RX-7

SUBJECT Battery Clamp Bolt & Nut.

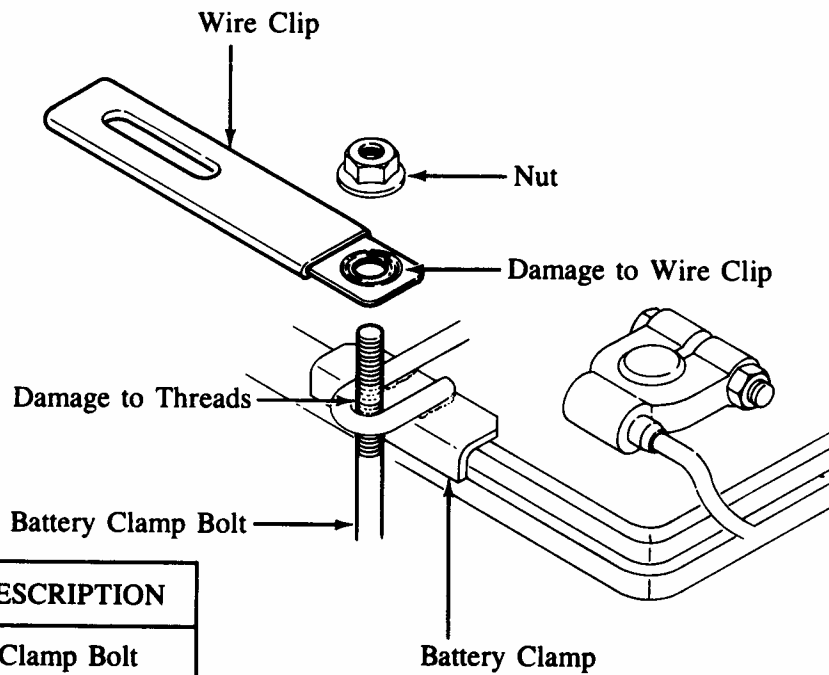
During installation of the battery clamp rod and nut, it is possible for wire clip to become pinched in the threads on the clamp bolt, resulting in the nut binding on the clamp rod.

1. Carefully remove the nut from the battery clamp bolt.
2. Use a die to repair the threads on the clamp bolt.
3. Install a small washer on top of the wire clip to prevent damage to the threads on the clamp bolt during reinstallation.
